**STAFF REPORT**  
**DEVELOPMENT SERVICES DEPARTMENT**

**Project Name:** Gateway Medical Plaza

**Application:** Subdivision Resurvey

# GATEWAY MEDICAL PLAZA: A SUBDIVISION OF MARGATE PLAZA NO. 1

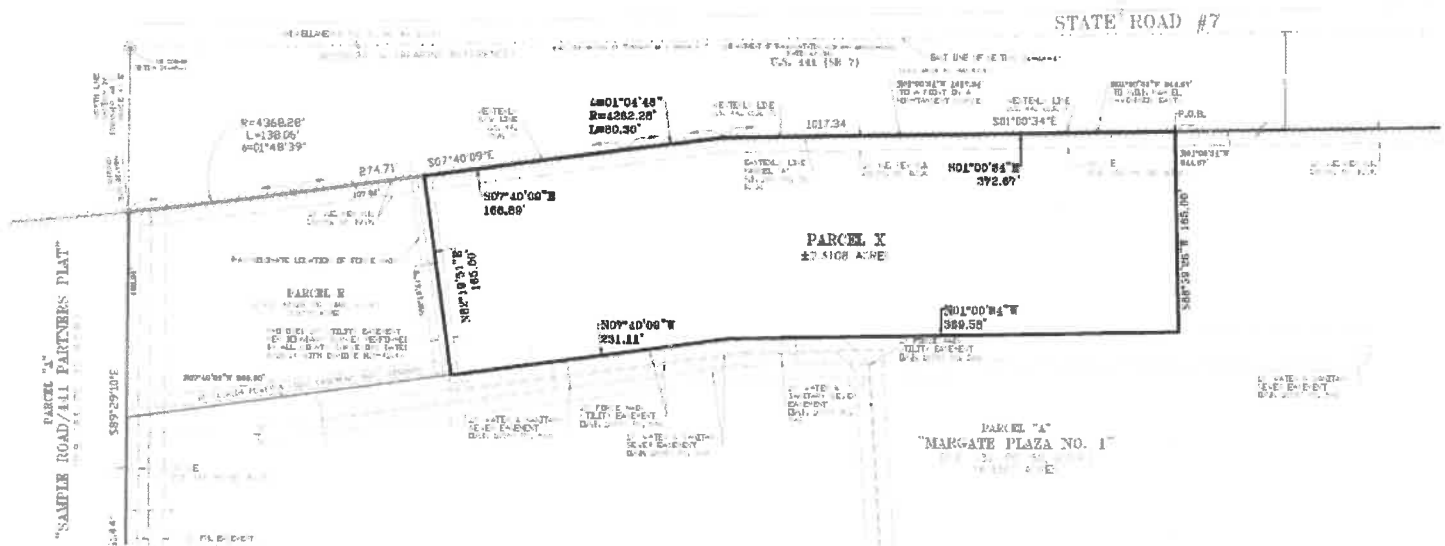
Applicant has requested creation of a new ~2.3 acre parcel within Penn Dutch Plaza (Margate Plaza No. 1 132-50) for the purpose of building a new two-story medical office building. Staff recommends approval subject to the condition of the applicant dedicating a utility easement that is 12 feet wide and traverses the property east-west, roughly where the shopping center used to have a driveway connection to State Road 7.
